PUBLIC UTILITIES COMMISSION OF THE STATE OF CALIFORNIA

RESOLUTION SU-5  
May 22, 1990

RESOLUTION SU-5, ORDER AUTHORIZING RULE  
CHANGES TO GENERAL ORDER NO. 95 (G.O.95)  
RULES FOR OVERHEAD ELECTRIC LINE CONSTRUCTION

SU-5  
APPENDIX A  
PROPOSED RULE CHANGES  
RULES FOR OVERHEAD ELECTRIC LINE CONSTRUCTION  
GENERAL ORDER NO. 95

FIGURE 54-1

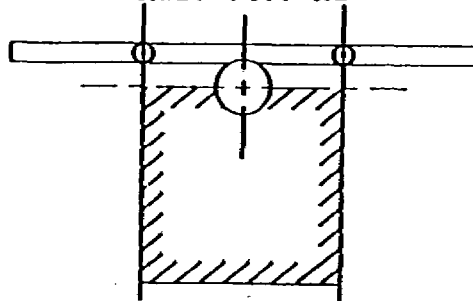
43           (1) Dimensions Where Line Arms Only Are Involved: The  
44 climbing space where line arms without related buck arms are  
45 involved on poles or structures shall be on one side or face  
46 of the pole, with the center line of pole approximately  
47 midway on one side of the climbing space (See Figure 54-1.),  
48 and shall have the following dimensions:

#### NEW LINES 54 THROUGH 57 (Figure 54-1)

This moves the pictorial representation of the rule from the existing Appendix G, Figure 16 to the body of the rule for easier reference.

CLIMBING SPACE  
LINE AND BUCK ARMS  
LESS THAN 4-FOOT SEPARATION  
Rule 54.7-A2b

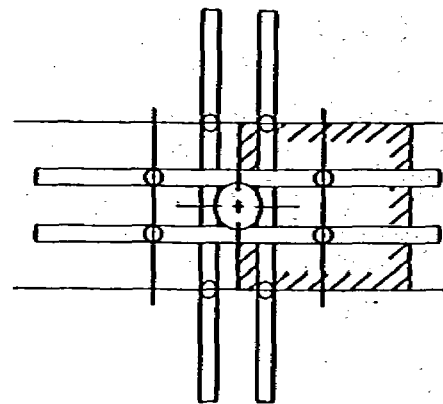
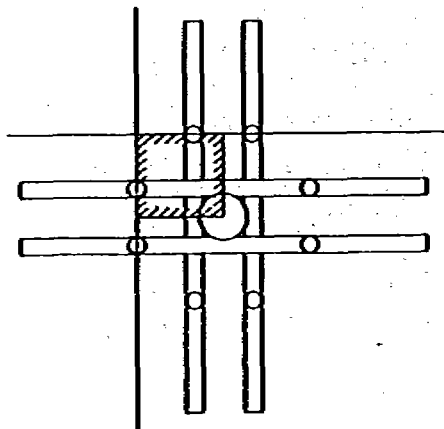
(b) Where the Vertical Clearance Between Conductors on Line and Buck Arms is Less Than Four Feet: The climbing space shall be provided through such levels and located in a quadrant and shall have at least the following dimensions (See Figure 54-2.).

For circuitry located at pole top, the climbing space

This change modifies the existing horizontal dimensions of line arm and related buck arm climbing spaces and the method by which they are determined.

CLIMBING SPACE  
COMBINATION ARM CONSTRUCTION  
LESS THAN 4-FOOT SEPARATION  
Rule 54.7-A2c

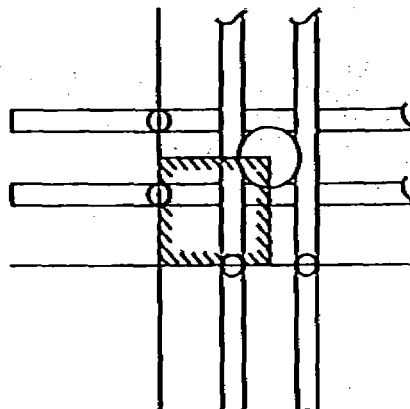
Where the vertical separation between conductor levels on line and buck arms is less than 4 feet such separation shall not be less than 2 feet, and the climbing space shall not be less than prescribed in Rule 54.7-A2b and the dimensions shall be in accordance with the highest voltage adjacent to the climbing quadrant (See Figure 54-4.).

This change simplifies climbing space requirements for combination crossarm construction when line and buck arms are involved.

Crossarms, supporting conductors of different voltage classifications, are rarely used in California; however, to be consistent with the proposed climbing space rule changes previously described under new lines 43 through 83, it is necessary to revise the present combination line and buck arm climbing space requirements.

NEW LINES 97 THROUGH 104 (Figure 54-4)

FIGURE 54-5

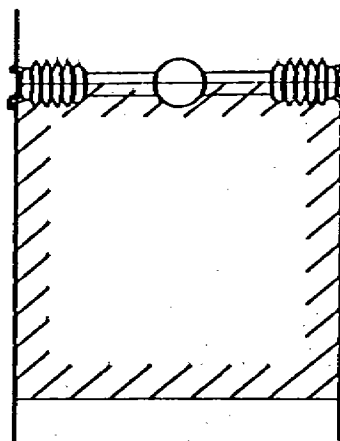
138 Exception: For a circuit at the top of the pole, the  
139 climbing space shall be maintained to the lowest conductor of  
140 the circuit on the climbing side of the pole (See Figure 54-  
141 5.).

#### NEW LINES 151 THROUGH 155 (Figure 54-5)

FIGURE 54-6

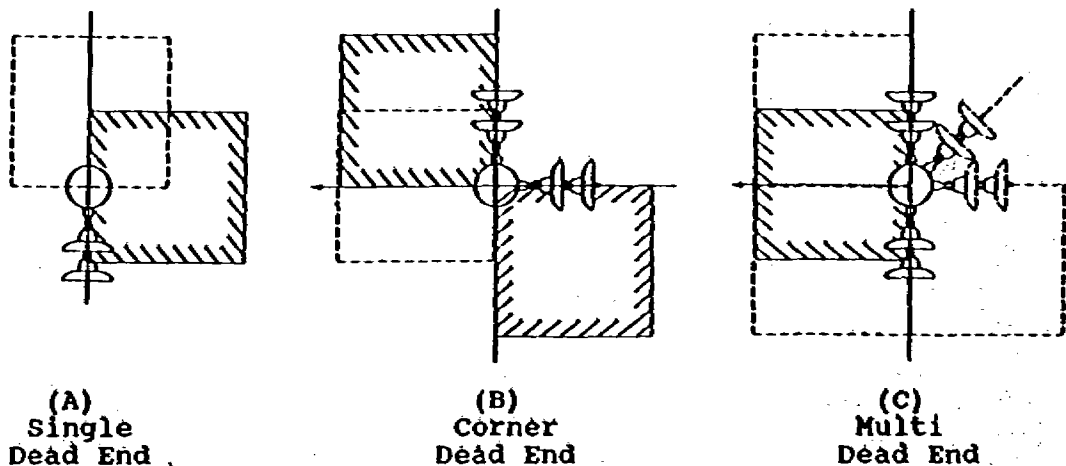
(2) Dimensions Where Conductors Are Deadended In Vertical Configuration: Climbing space through conductors shall be a square of the horizontal dimensions tabulated below, and shall be located either on one side or a quadrant of the pole (See Figure 54-6.).

#### NEW LINES 167 THROUGH 173 (Figure 54-6)

This moves the pictorial representation of the rule from the existing Appendix G, Figure 15 to the body of the rule for easier reference. Added second and third pictorial to clarify climbing space requirements.

New Lines 18-20  
(Rule 52.4)

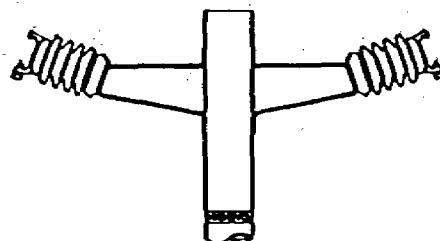
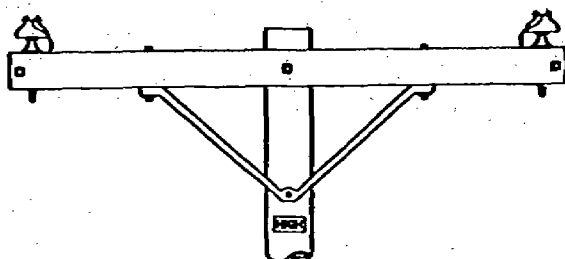
Painting crossarms to denote high voltage is a practice no longer followed by the majority of electric utilities. Instead, lettered high voltage signs have been universally adopted as a more appropriate and effective means of warning. It is proposed that painting of crossarms be deleted as an option.

FIG. 54-7

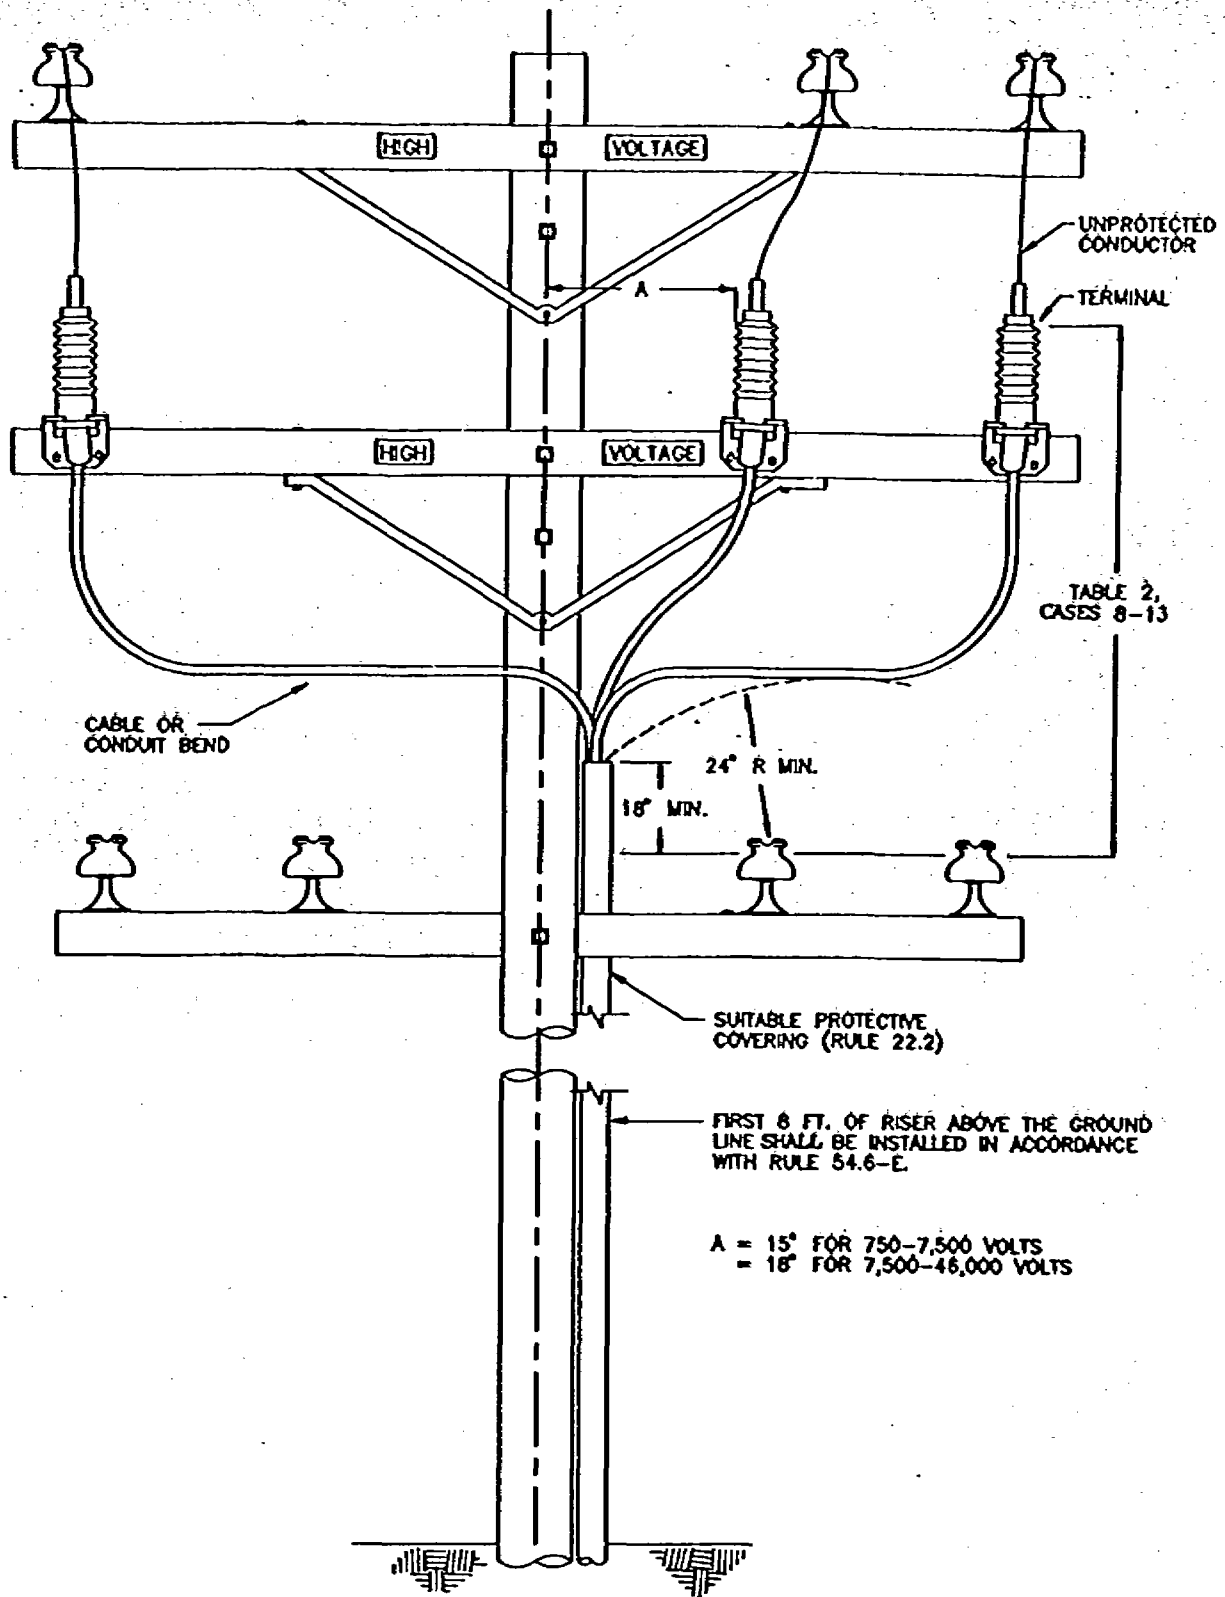
Delete Fig. 61, App. G titled SUPPLY RISERS AND TERMINALS and add "This page intentionally left blank".

The language of paragraph 3 of Rule 54.6-F is being simplified and the reference to Appendix G, Figure 61 changed to Figure 54-7. Appendix G, Figure 61 is being deleted and new Figure 54-7, an updated diagram of supply risers and terminals, will appear in the text of the rule below paragraph three.

FIGURE 54-8

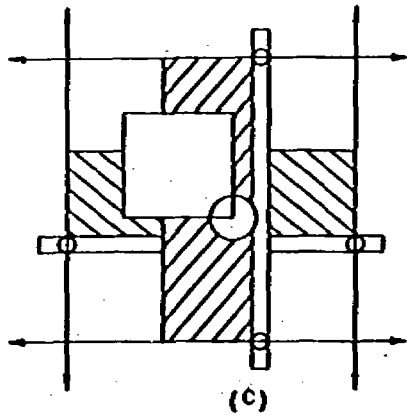
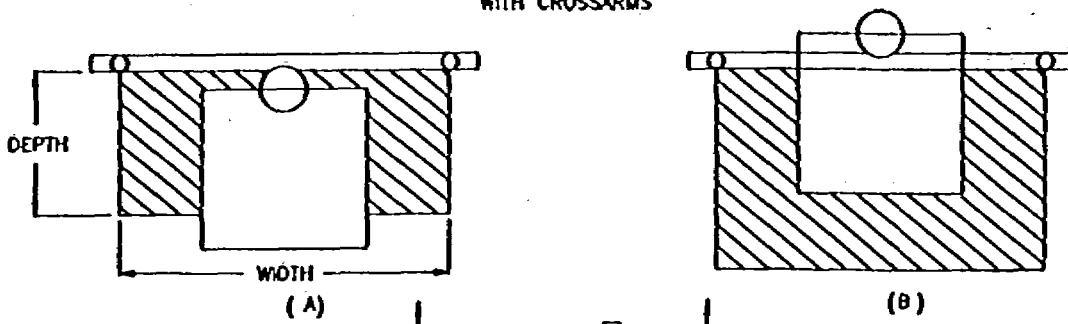
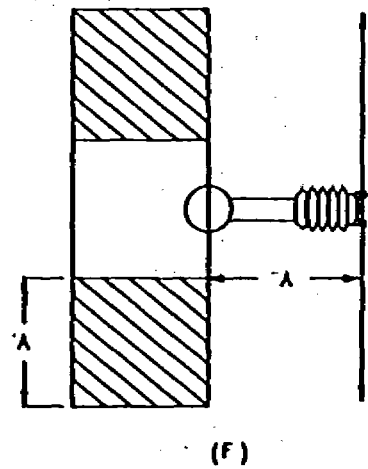
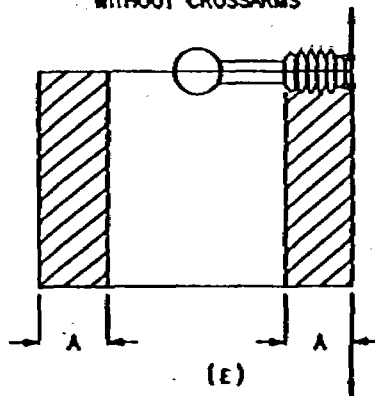
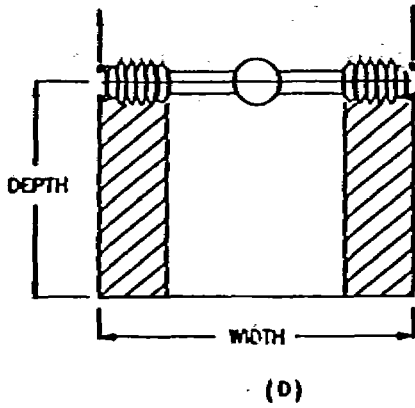
The width of the working space where crossarms are not involved (e.g., vertical and triangular construction without crossarms) shall extend from the climbing space to the outmost conductor position on the conductor support involved. The depth of the working space shall have the same dimension as the climbing space and shall be measured from the centerline of pole (See Figure 54-8D). When conductors are located on one side of the pole only (e.g., vertical construction) the dimensions of working space shall be applied as illustrated in Figures 54-8E and F. When climbing space is located in a quadrant, working space shall be applied as illustrated in Figure 54-8G.

Over the years, overhead line construction has changed to include other types of conductor supports besides crossarms (e.g., metal and fiberglass supports). Presently, Rule 54.7-B1 only addresses allowable working space dimensions when crossarms are involved. Working space dimensions for other types of conductor supports, as in armless construction, needs to be addressed. This rule change will assure that working space is provided for workers above, below, and between conductor levels, regardless of the type of construction.

Illustrations have been added to the text to facilitate the application of working space.

GANG OPERATED SWITCHES  
 CLIMBING AND WORKING SPACE  
 Rule 58.5-D

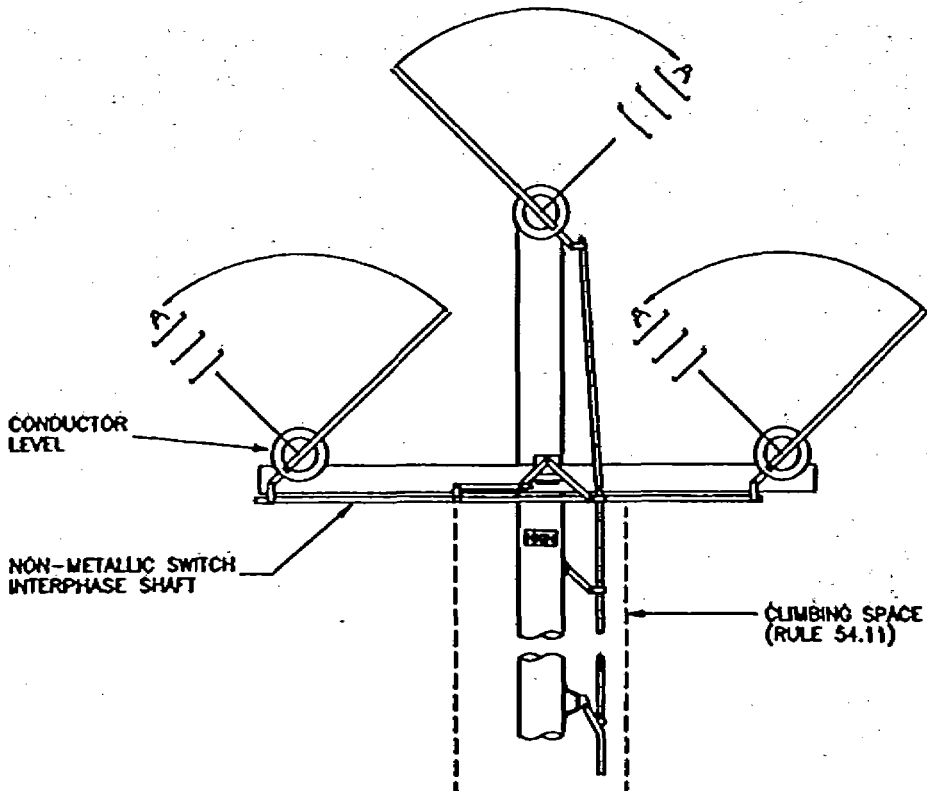
There are many gang operated air switches in service throughout the state, mounted in the pole top position. This proposal modifies Rule 58.5-D so it would permit certain parts of switches to be considered allowable climbing space obstructions provided they are non-metallic or if metallic not in contact with, or bonded to, hardware that can become energized through the failure of an insulator.

This modification of Rule 58.5-D would not impose any additional safety concerns for workers or restrict their use of climbing space.
